CONSTRUCTION DOCUMENTS
FALCON MEADOWS AT BENT GRASS FILING NO. 1
FOR
CHALLENGER COMMUNITIES, LLC
BENT GRASS MEADOWS DRIVE & MERIDIAN ROAD
FALCON, CO 80831 - EL PASO COUNTY

INTERSECTION DETAILS

BENT GRASS MEADOWS DR. & ROWENA WAY DETAIL GRADING

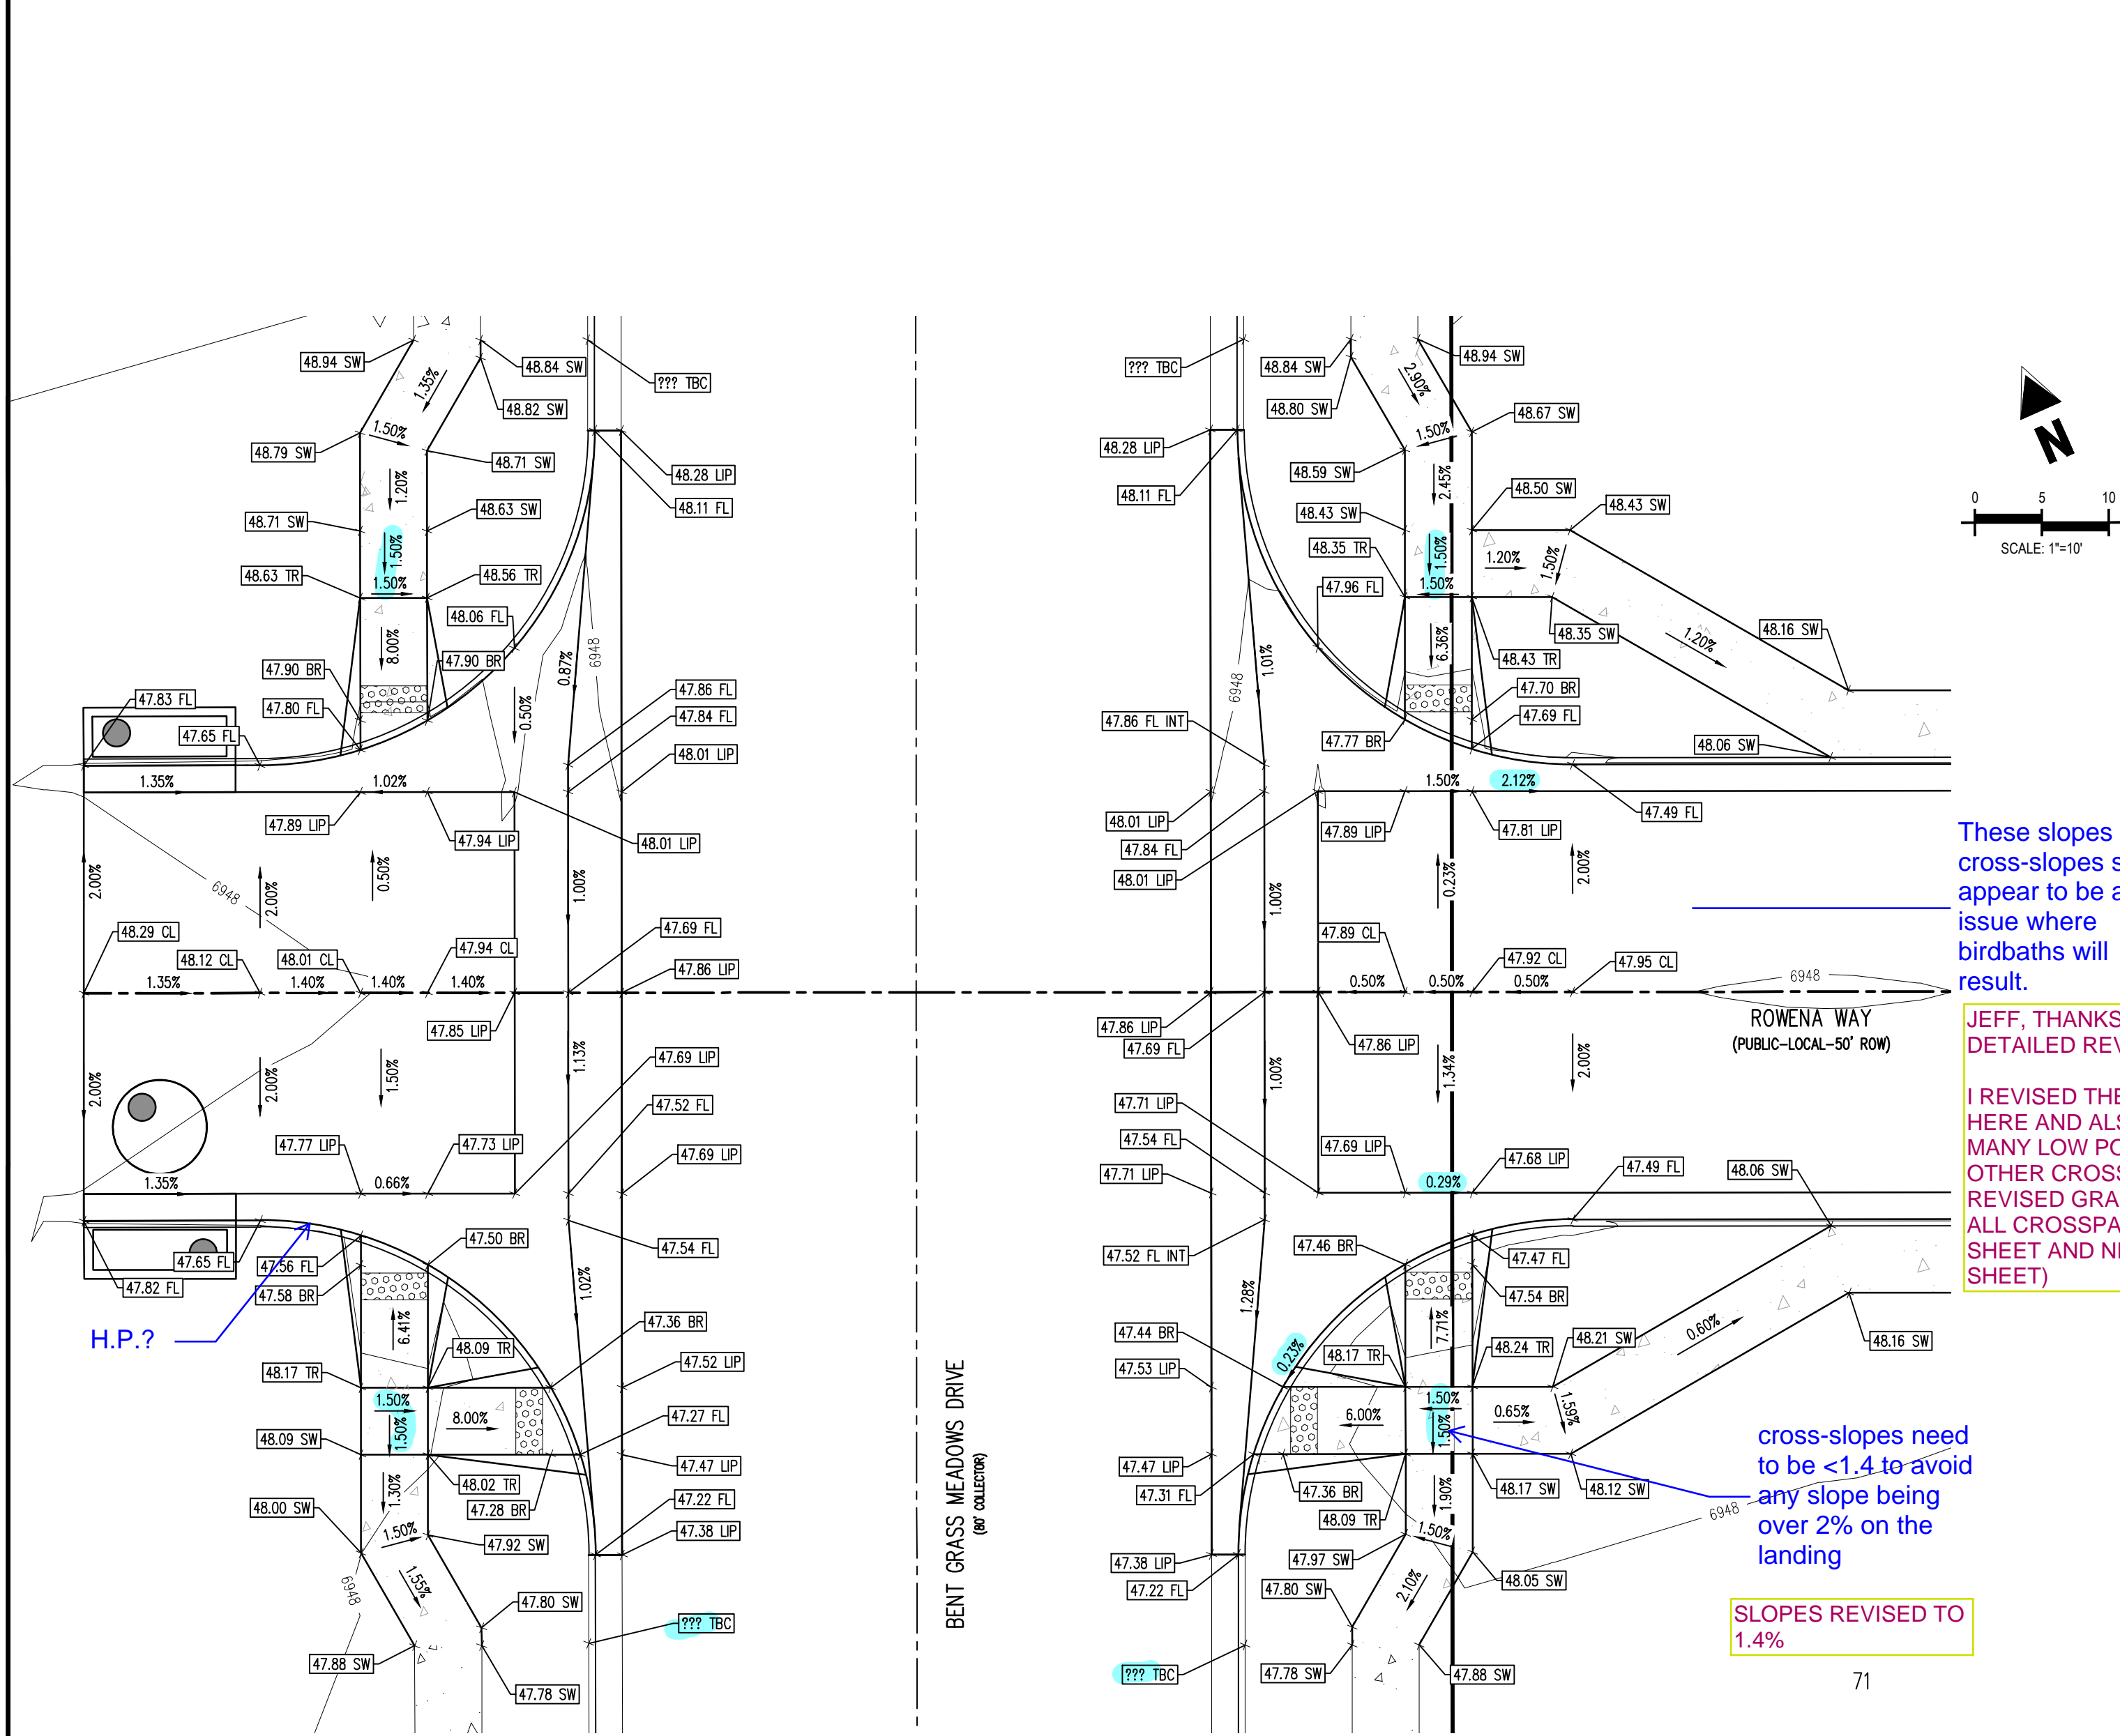
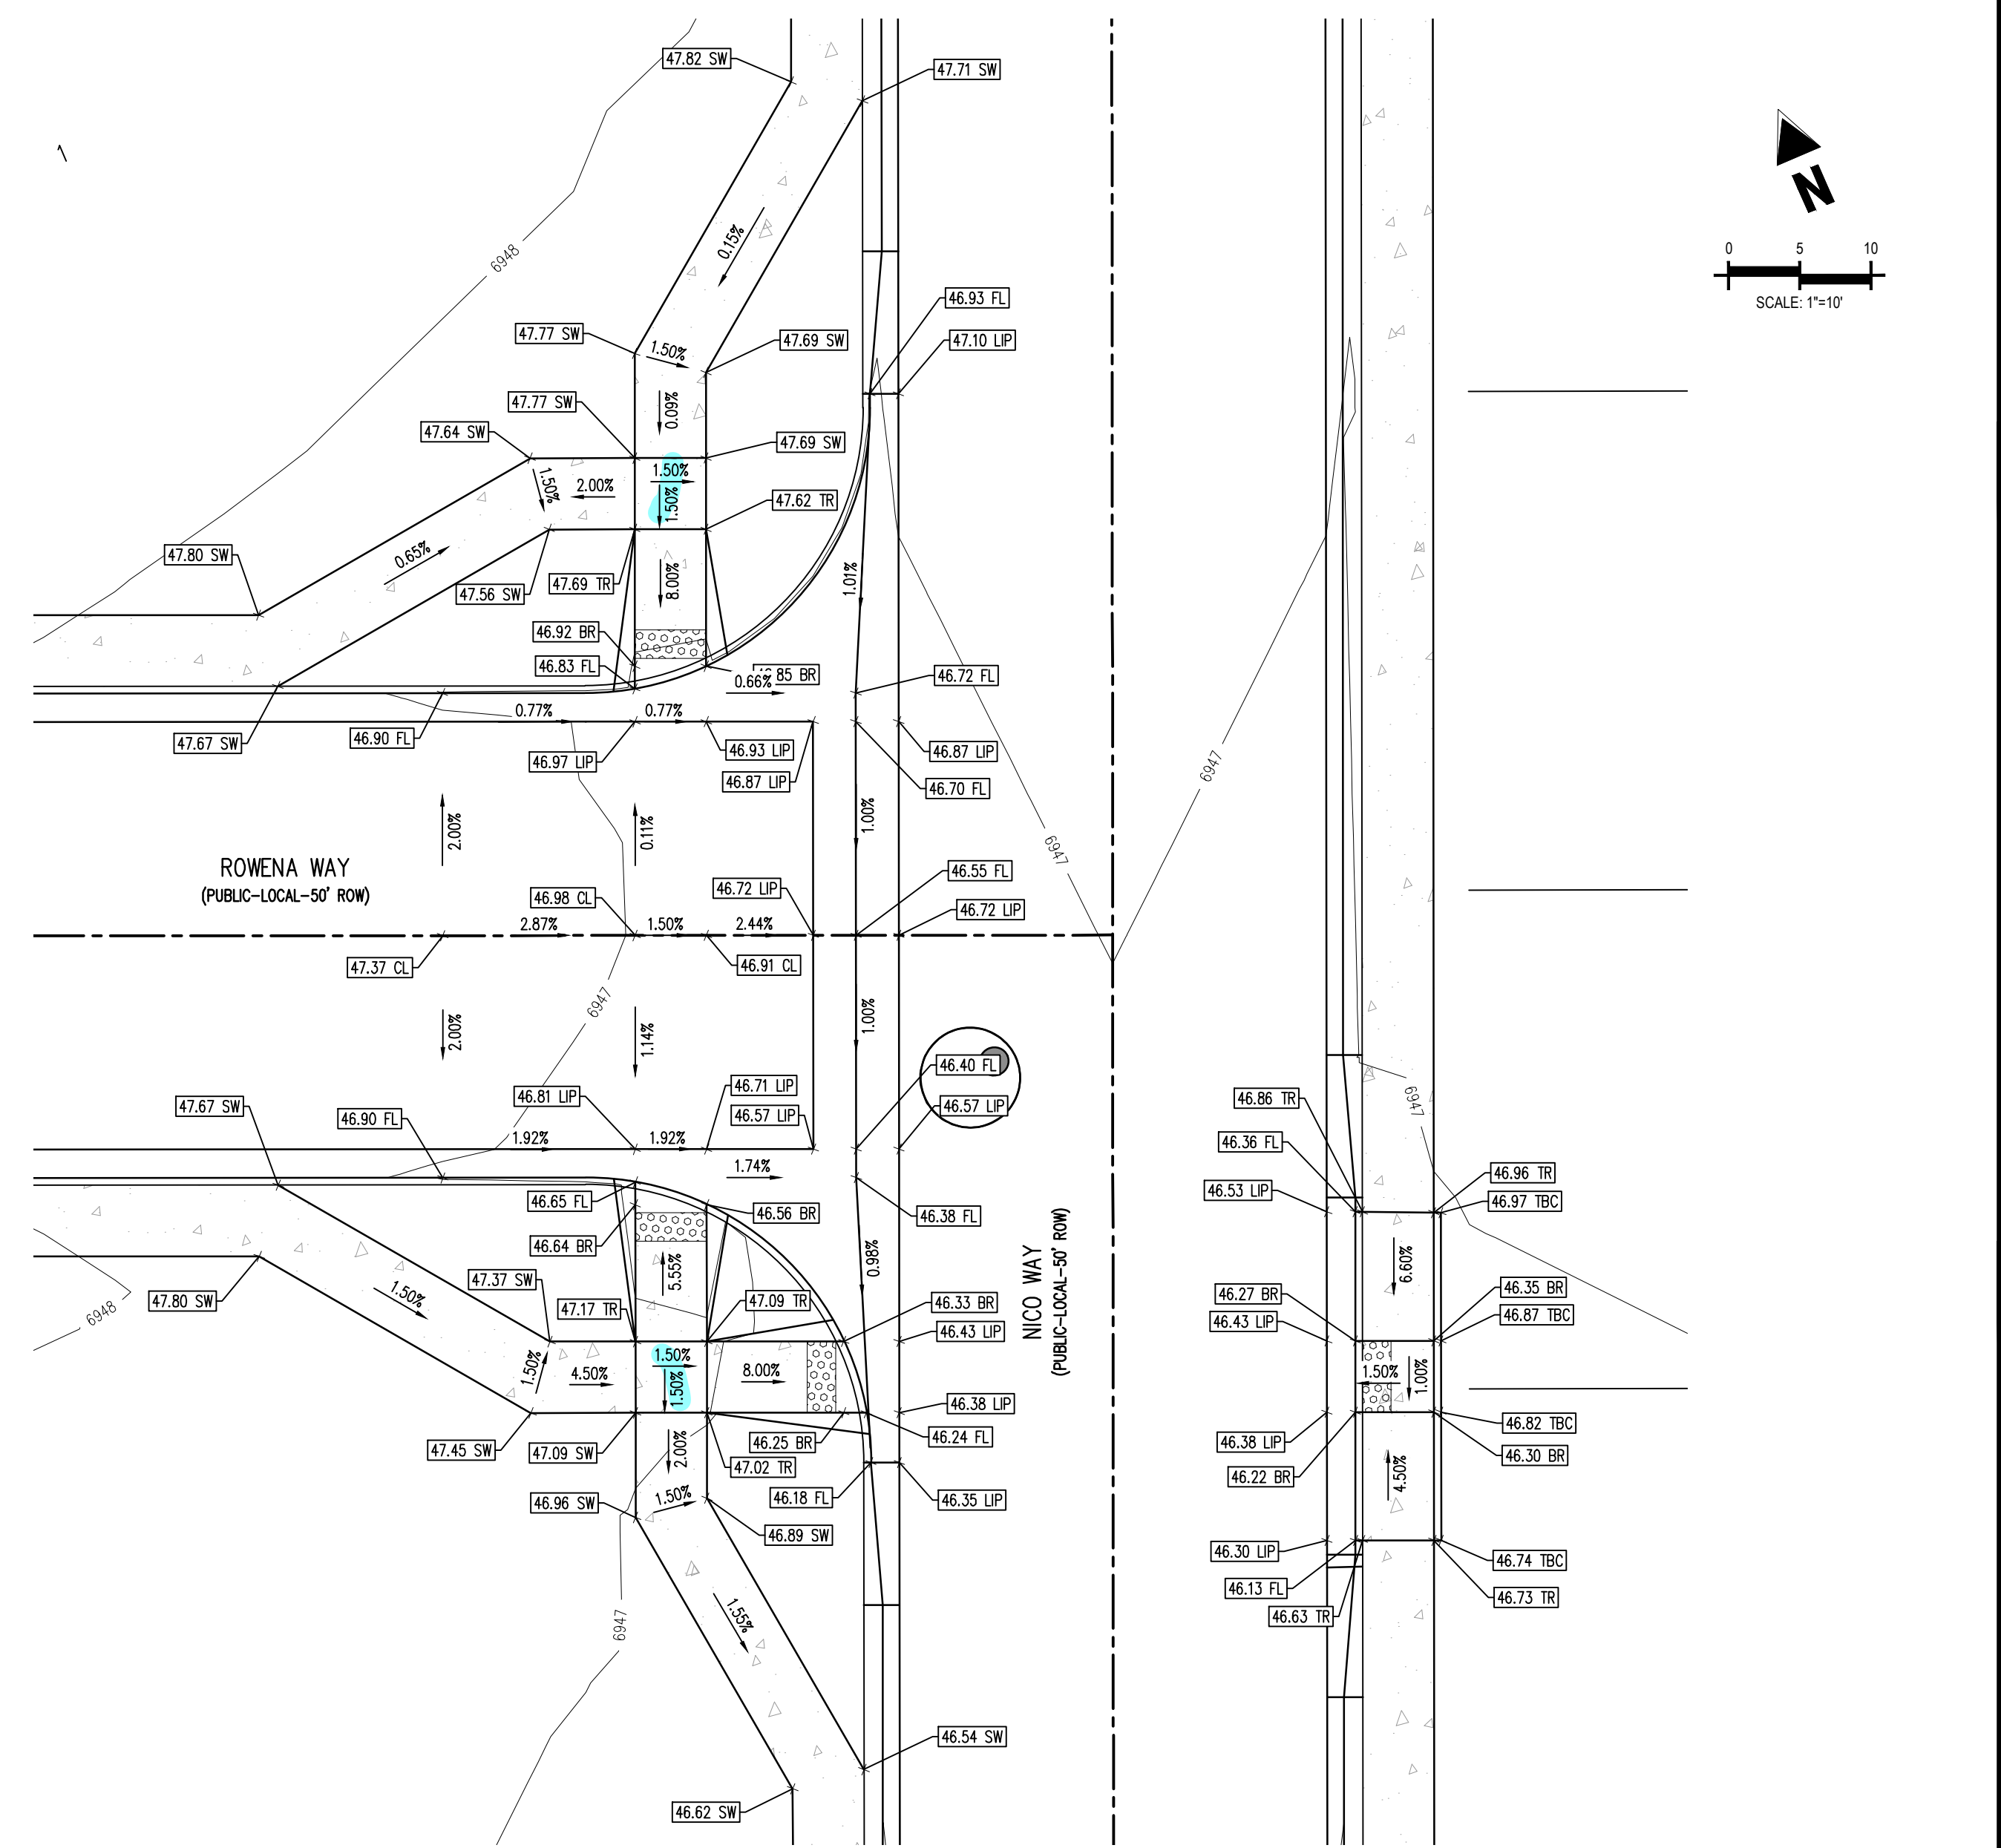
These slopes and cross-slopes still appear to be an issue where birdbaths will result. JEFF, THANKS FOR THE DETAILED REVIEW. I REVISED THE SLOPES HERE AND ALSO FOUND MANY LOW POINTS IN OTHER CROSSPANS. REVISED GRADING ON ALL CROSSPANS (THIS SHEET AND NEXT SHEET)

cross-slopes need to be <1.4 to avoid any slope being over 2% on the landing SLOPES REVISED TO 1.4%
